Discus III Service Replacement

EMERSON™
Climate Technologies

New Discus III 4D & 6D Models

Discus II Service Brackets

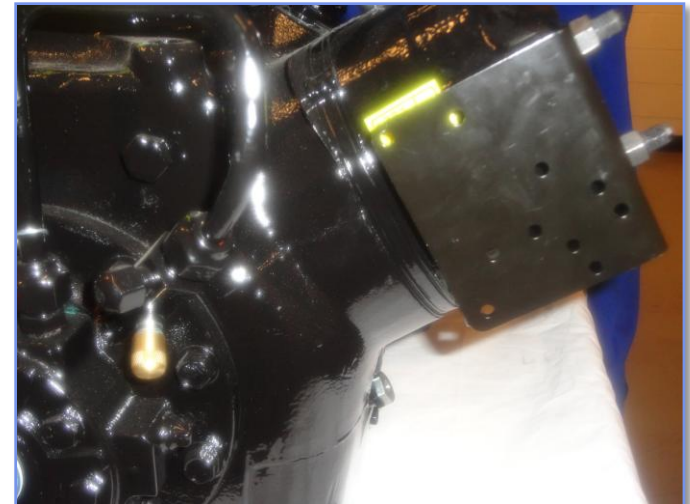
- As Of May 1st, 2013 All Discus II Service Compressors Will Include The Universal Bracket Installed On The Compressor.
- Discus II Models Built Before May 1st 2013 will Require The Universal Mounting Bracket Kit (974-1315-00)

Universal Bracket Compatible With

- CoreSense Protection

- Sentronic + and Sentronic III

Discus II Service Brackets

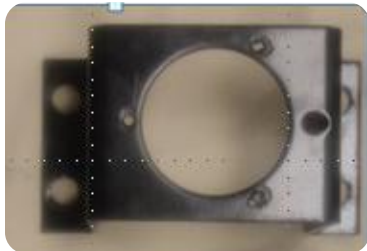
- Aug 1st 2013 All Discus II Service Compressors Will Include The Low Temp Bracket Kits.
- Compressors Built Before July 2013 Will Require Mounting Brackets If The Compressor Is Equipped With Head Fans and/or Demand Cooling.

4D Head Fan Bracket, Demand Cooling Bracket and Parts Bag.

6D Head Fan Bracket, Demand Cooling Bracket and Parts Bag.

Unique DIII Service Model Requirements

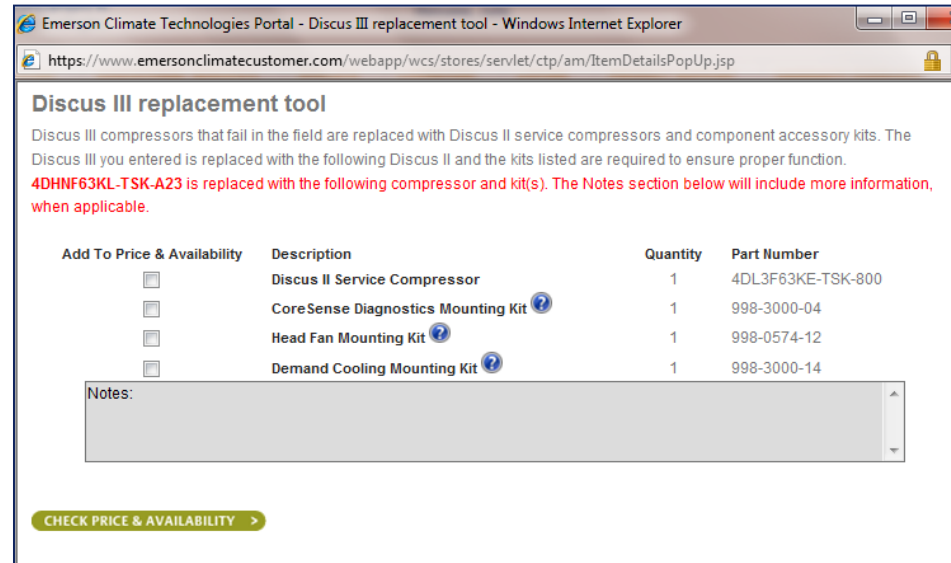
- **Discus III Models (6DU/V)**

- **Service Replacement Will Be A Discus III Model (6DU/V -800 BOM)**

- **Discus III With -A00 BOMs Will Require Special Bracket Kit**

- **See Copeland Discus III to Discus II Cross Reference (2012 DS-47) For Correct Kit Numbers**
